## **ADDENDUM #1**

### **WINGFIELD HILLS RD STORM DRAIN IMPROVEMENTS**

**BID #18/19-022**

MANHOLE TYPE IV-A

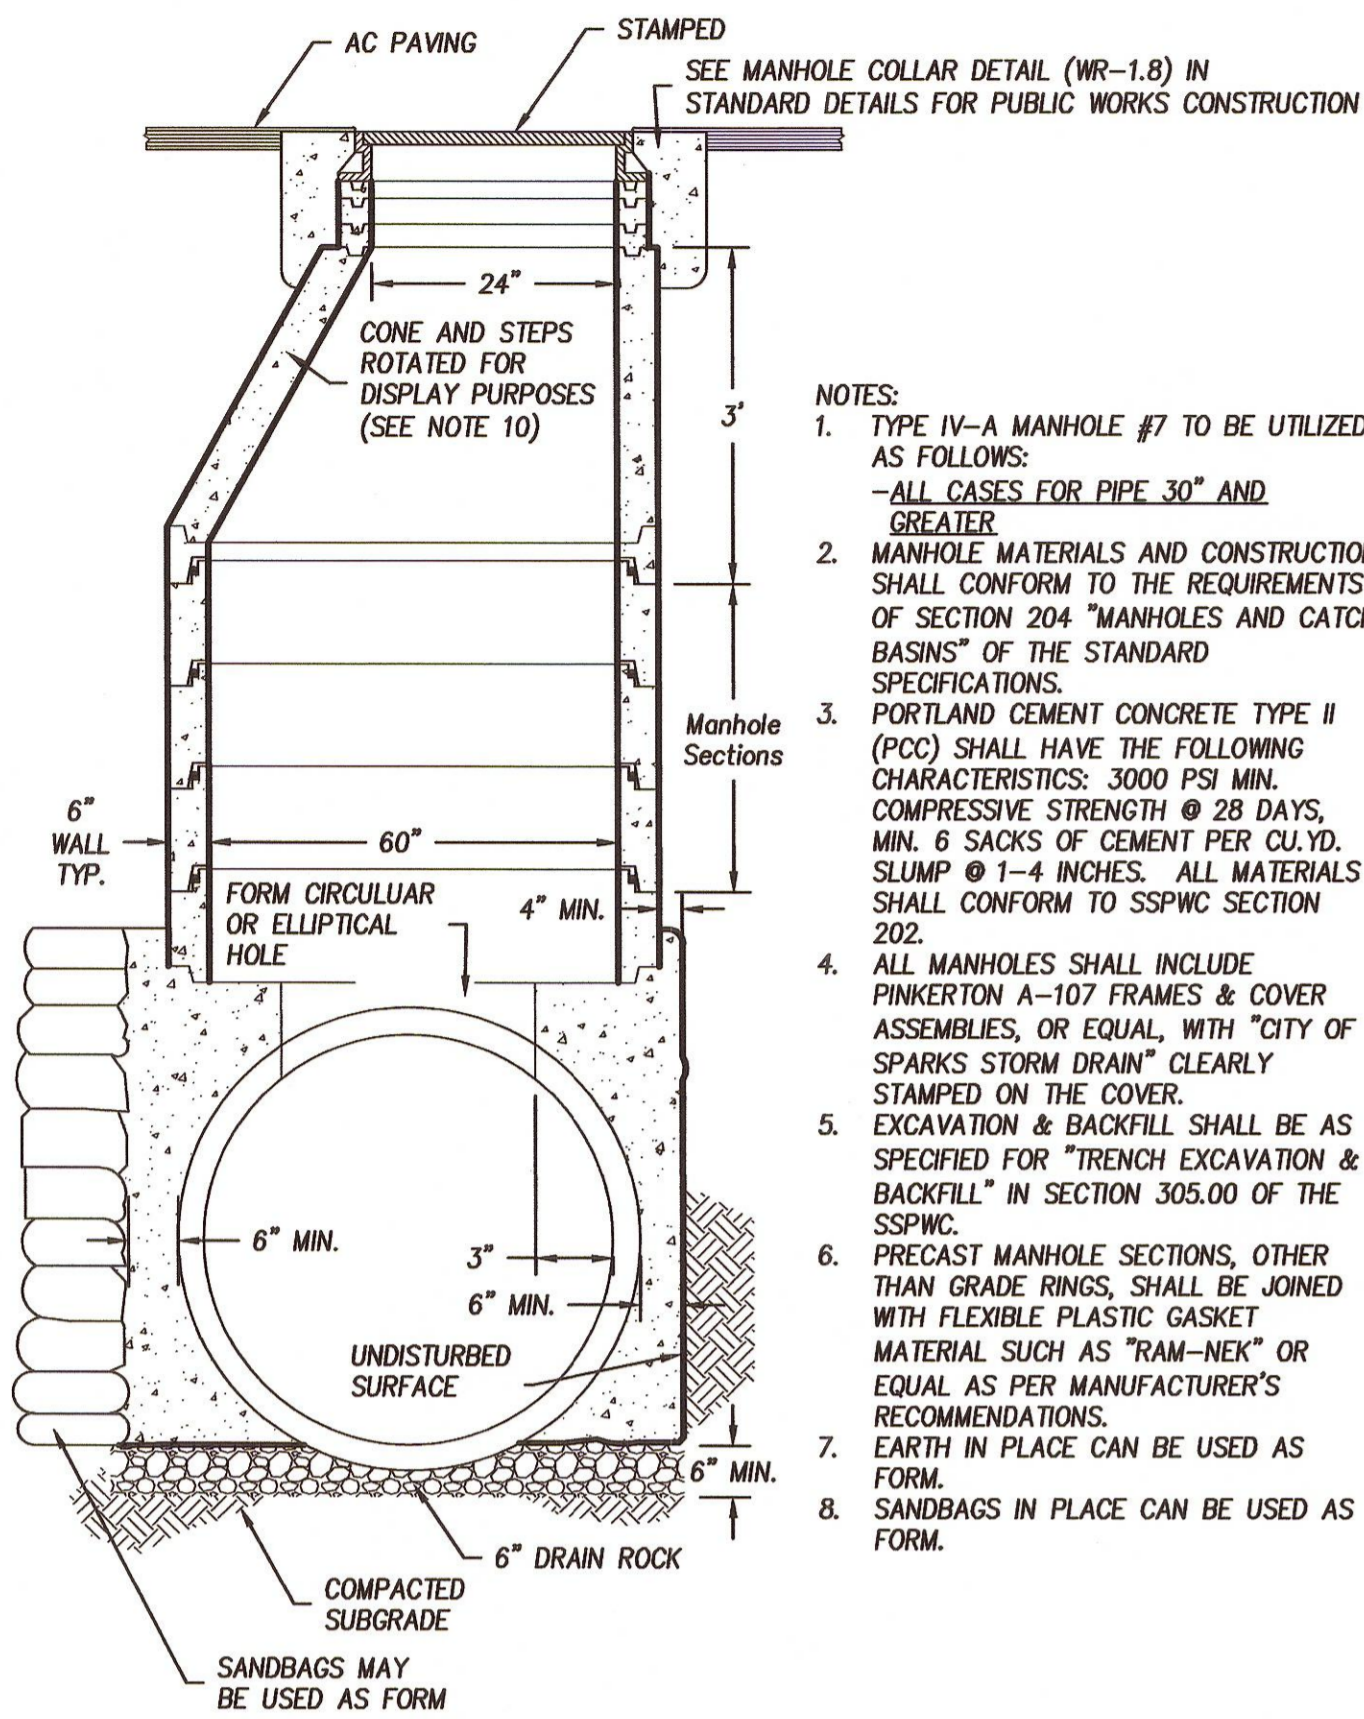
MANHOLE #7 HAS MODIFIED COLLAR & LID DUE TO SHALLOW DEPTH  
(NO CONICAL SECTION)
